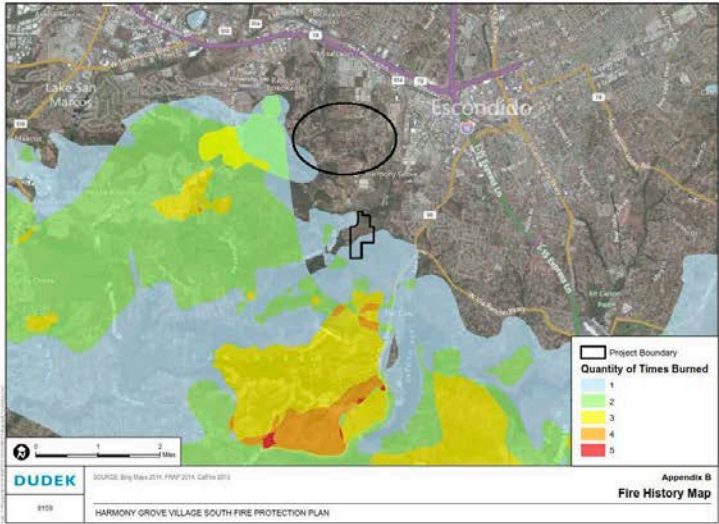
COMMENTS	RESPONSES
	<p>acknowledged lack of fire-fighting resources as 1,300 personnel, 164 fire engines, 27 hand crews, 11 dozers, and 15 aircraft were assigned to the Cocos Fire, still allowing similar, proportional resources for the other fire events (County of San Diego OES May 2014 San Diego County Wildfires After Action Report, June 2016; incorporated by reference). These comments are not in variance with the FPP's/DEIR's analysis or conclusions.</p> <p>The Coco's fire ran out of fuels near the Escondido Industrial Park west of Citracado Parkway. Development of new, ignition-resistant buildings and maintained, fire-resistive landscapes starved the fire of fuels and it was controlled. On the other fire front that approached the Harmony Grove Viliage South (HGV South) Project site, firefighters were able to hold the fire at Country Club Drive near Harmony Grove Road due to a weather shift and lack of continuous fuels (Battalion Chief Christopher, Laguna Beach Fire Department, personal communication October 2016; incorporated by reference)</p> <p>Unfortunately, most homes lost in wildfires, including the Cocos Fire, can be attributed to: (1) older construction that does not include ignition-resistant materials and methods that are required of new structures in the wildland urban interface and VHFHSZs, and (2) lack of maintained fuel modification zones (CAL FIRE 2007 – Wildland-Urban Interface Building Codes).</p> <p>Photographs provided in the comment regarding the Cocos Fire entering south Harmony Grove are noted. The comment mentions a spot fire contributing to the fire spread rates, which is consistent with the Project's FPP fire behavior analysis.</p>

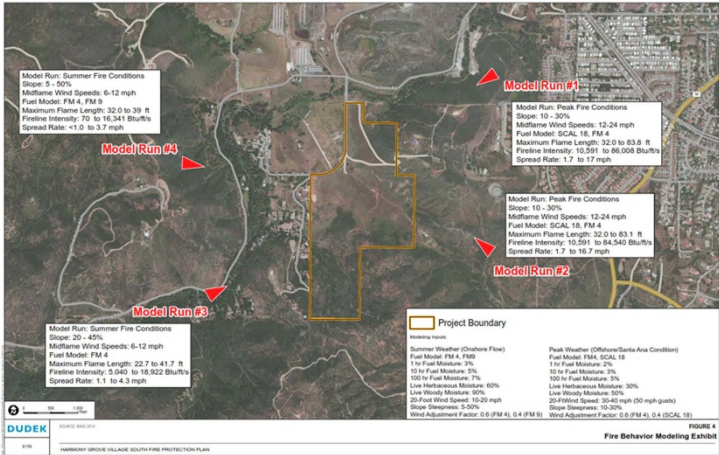
The fire modeling scenarios noted in the FPP (Figure 4-below), indicates fire speeds of up to 17 mph coming down the Escondido Creek canyon from the area of the western border of the City of Escondido. This is a likely ignition point since there is a homeless encampment in the creek within the Escondido city limits just east of the County line. This is about 1.2 miles from the intersection of Harmony Grove Road and Country Club Drive and a flame speed of 17 mph is covering just under 25' per second. 1.2 miles is 6336' and at 25' per second the fire line would be expected to reach the single way in and out of HGVS from the city limits of Escondido is approximately 4 minutes. This is far less time than the best case scenario of a 30 minute evacuation time of the project and in a situation like this, the community is now in a shelter in place situation.

The plan does not clearly state to where this 30 minute evacuation time gets the residents from HGVS, and the surrounding existing residents. Is it merely to the intersection of Harmony Grove Road and Country Club Drive, or is it completely out of Harmony Grove into Escondido or San Marcos? If it is the
